# Service Bulletin No. 392

<b>MODEL</b> D Series Coaches	<b>TYPE</b> Field Change Program	<b>SECTION/GROUP</b> 7--Electrical	<b>DATE</b> Dec. 7, 2012
<b>SUBJECT</b> ACTIA MULTIPLEX CHECK ENGINE AND CHECK TRANSMISSION TELL-TALES			
<b>CONDITIONS</b>

**Figure 1. Program Rev. Level decal located on the front junction box frame.**

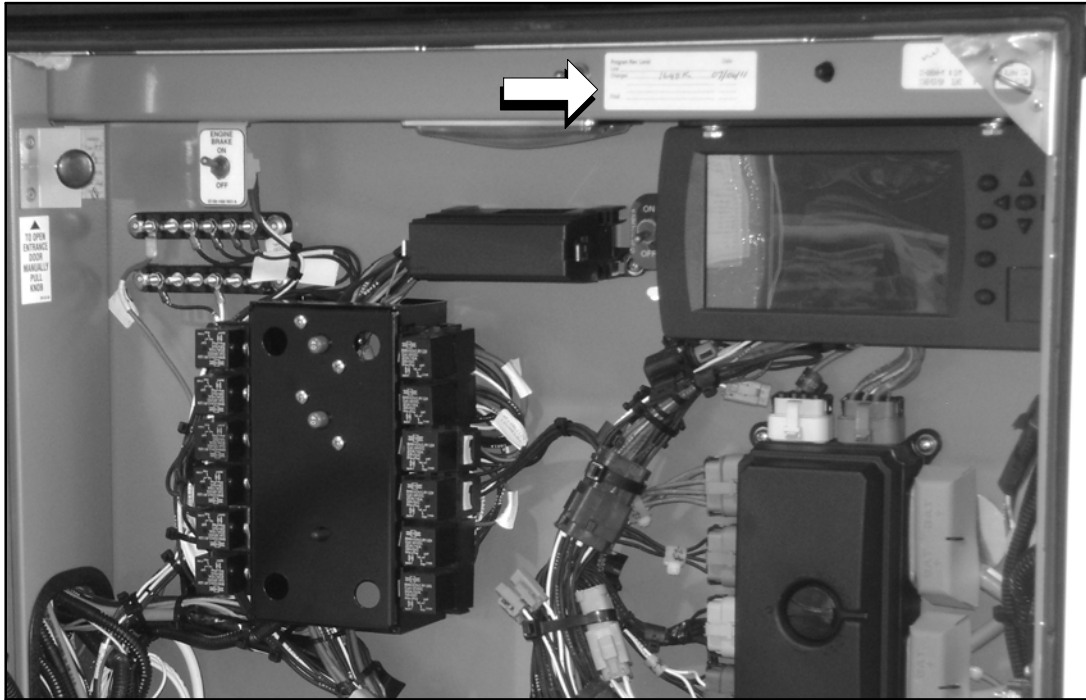
1. Position the rotary dial on the lower, LH console switch panel to ENGINE STOP. Ensure the main battery disconnect switch is in the ON position.
2. Connect the laptop to the coach, equipped with Amp reflash software, and download the new control logic.
3. Open the front junction box door. Locate the Program Rev. Level decal in the upper, RH corner ( refer to Figure 1 ).
4. Using a marker or pen, clearly print to update the Program Rev. Level decal by recording the new control logic revision level and the date the download occurred on the applicable line of the decal.
